# City of Richmond

## Report to Development Permit Panel Planning and Development Department

File: DP 12-617455

Re: **Application by Matthew Cheng Architect Inc. for a Development Permit at  
6511 No. 2 Road (formerly 6471, 6491 and 6511 No. 2 Road)**

Sheet Title: ELEVATIONS BUILDING A

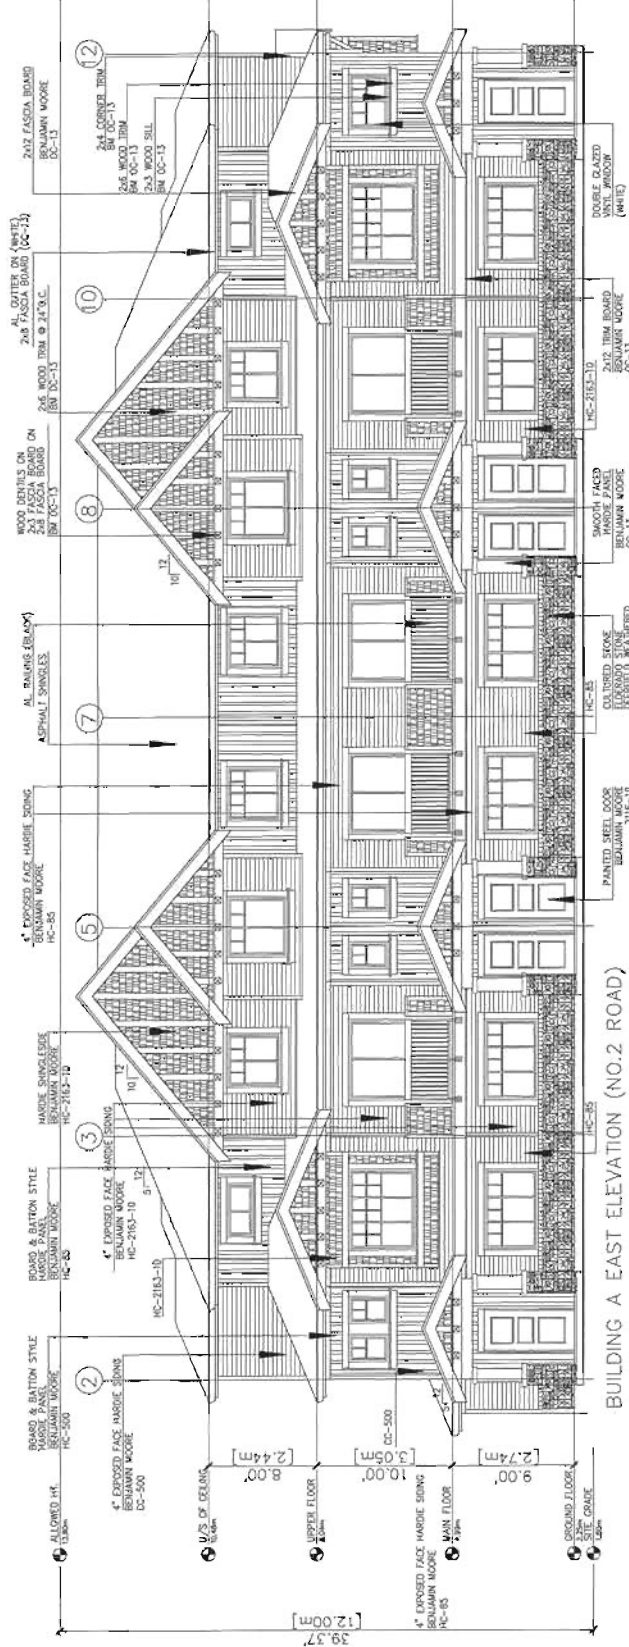
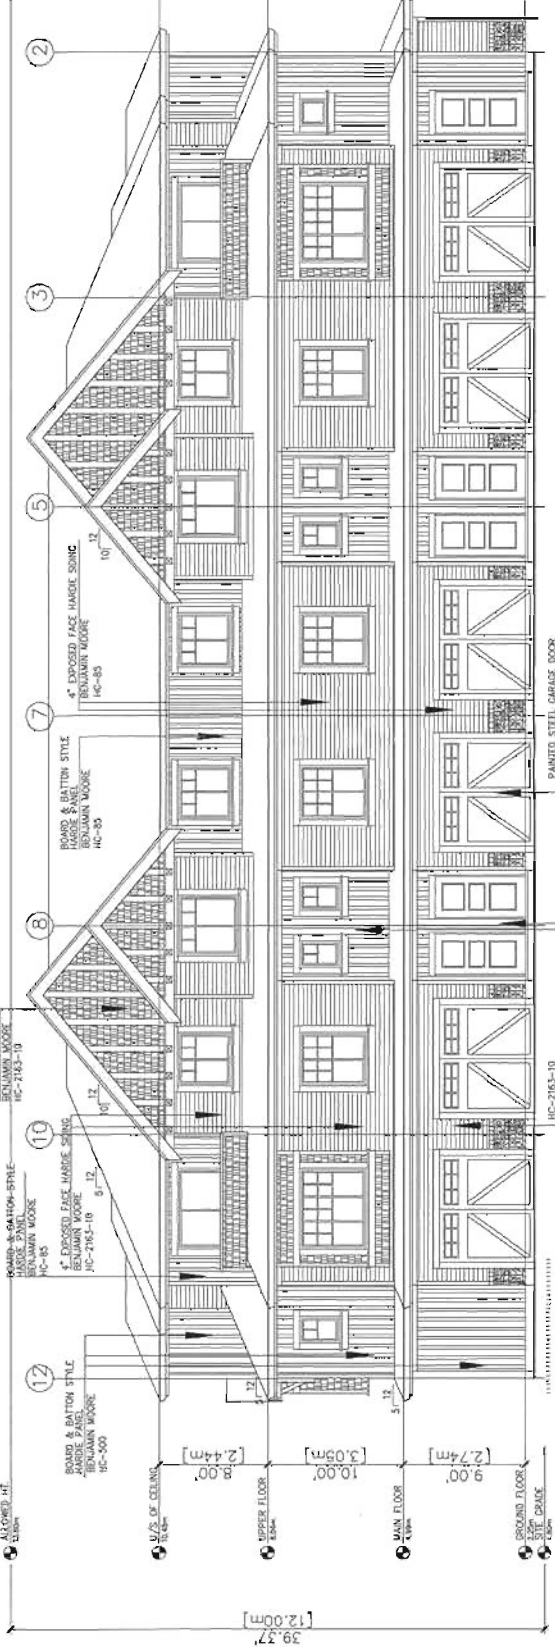
13. consider design development of units facing the interior driveway;  
*The north elevation of Building A and the south elevation of Building B have been revised with more windows and articulations.*

16. elevations of the end units appear a bit austere; applicant could use some more glass;  
*The north and south elevations of Building A and B have been revised with more windows.*

29. the north elevation of Building A and south elevation of Building B appear blank; consider adding at least a window near the turn to the internal drive aisle entrance to enhance the visual interest of motorists entering the project; and  
*The north and south elevations of Building A and B have been revised with more windows.*

Sheet Title:  
ELEVATIONS  
BUILDING E

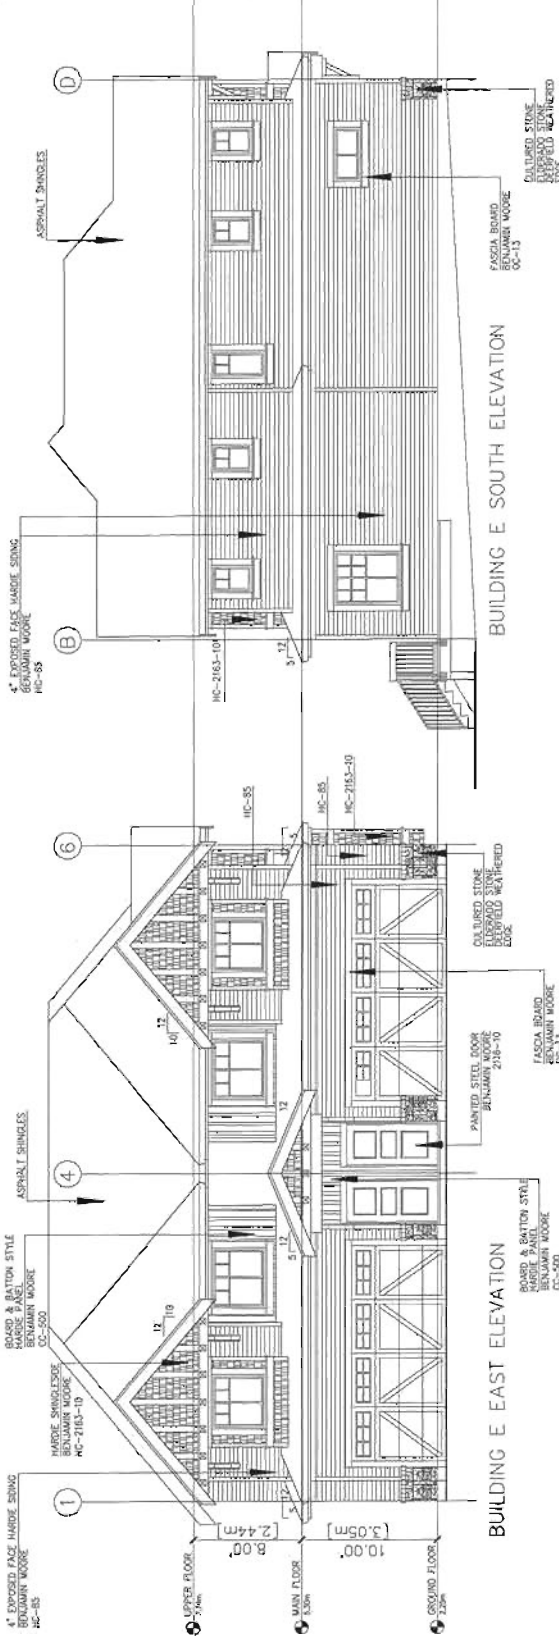
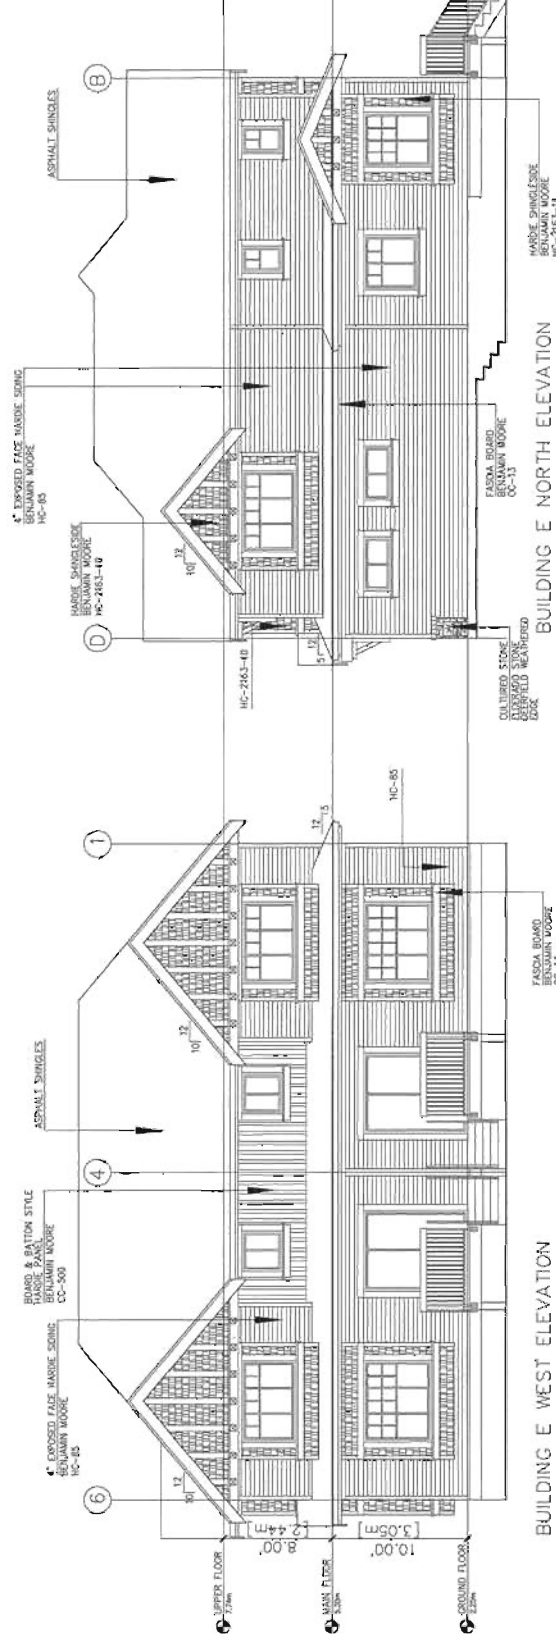
10. no CPTED concerns;
  - *A multitude of windows on the north elevation of Building E, the south elevation of Building D, and the west elevation of Building A look out on to the amenity area increase the level of surveillance.*

# ADAPTABLE OPTION FOR UNIT #112

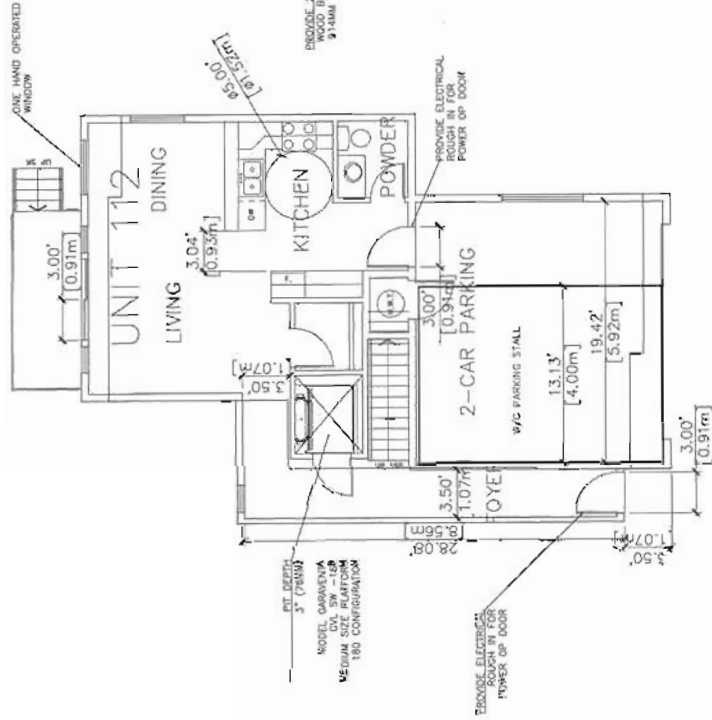
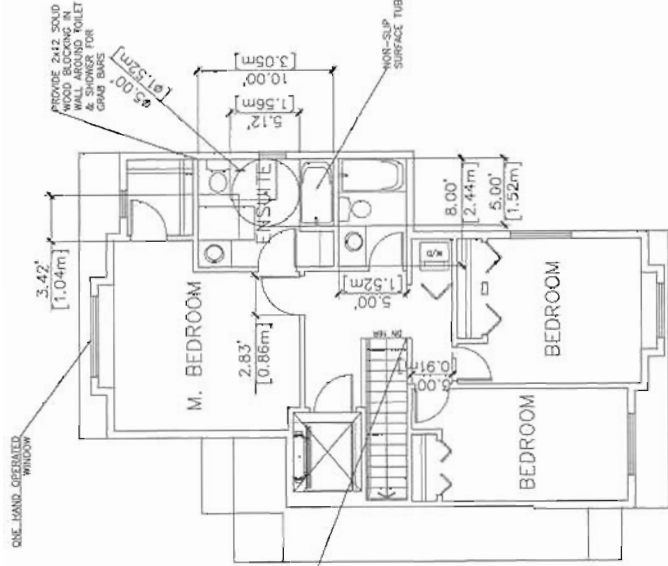
5. appreciate the provision of detailed drawings for the convertible unit; suggest that a sliding door be used in the powder room on the main floor to make it more usable; consider removing extra hallway space on the upper floor to create bigger bedrooms and a usable second washroom;  
*Noted. The convertible unit floor plans have been revised. See attached floor plans.*
